SERVICE BULLETIN

M-1382A

2014 FL TOURING HYDRAULIC CLUTCH - SAFETY RECALL CODE 0159

Reason for Revision

Figure 1. Recall Kit 91500068

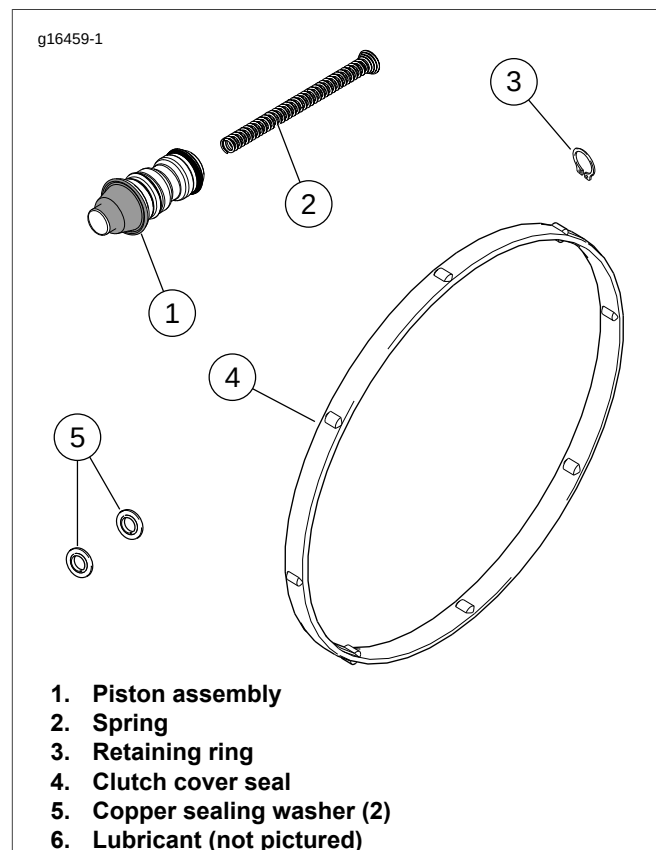
These motorcycles may develop a tear in the primary cup (seal) on the master cylinder piston. If this condition occurs the system may lose the ability to maintain enough lift to keep the clutch disengaged. If this condition remains undetected, it could allow the motorcycle to "creep" forward from a stop, which could lead to a loss of control of the vehicle possibly causing a crash.

Replace Clutch Master Cylinder Piston Assembly

Do not reuse any parts removed from the master cylinder piston bore. Use only the parts from the kit.

1. Confirm that the motorcycle is involved in Recall 0159. If the status includes an **open** for Safety Recall 0153, the 0159 should be performed and the 0153 will be closed by HDMC once the 0159 claim is approved.
2. Obtain the recall kit (Part No. 91500068).
3. Replace the clutch master cylinder piston assembly with parts from the recall kit. This kit is to be used on both original equipment clutch master cylinders and chrome accessory clutch master cylinders (Part No. 41700263 and 41700263A). See CLUTCH MASTER CYLINDER AND RESERVOIR in the service manual.
4. Fill and bleed clutch fluid system. See the service manual.
